Product Change Notification / GBNG-19TOBI439

CCB 4885 Initial Notice: Qualification of CEL-8240 GS as a new mold compound material for selected Supertex CL2xx, CL52xx, LND150, MCP15xx, MCP170x and MCP970xx device families available in 3L TO-92 package assembled at CRTK assembly site.

CCB 4885
Pre and Post Change Summary
PCN #: GBNG-19TOBI439

Lead Frame Comparison

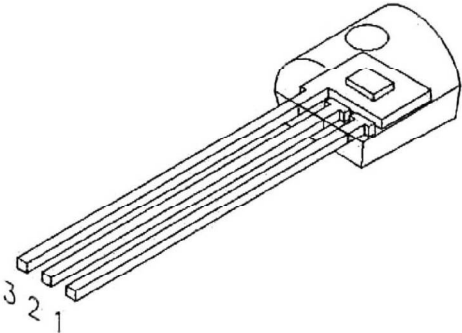
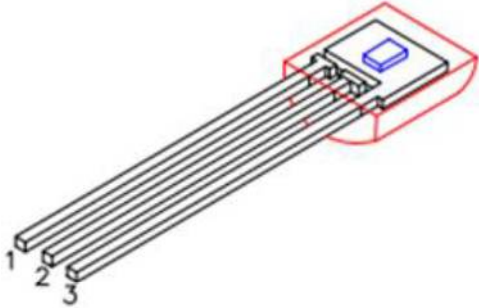
Note: Mold compound material fills the leadlock hole, which provides improved protection against moisture penetration along the edge of the leads (pins) of the package.
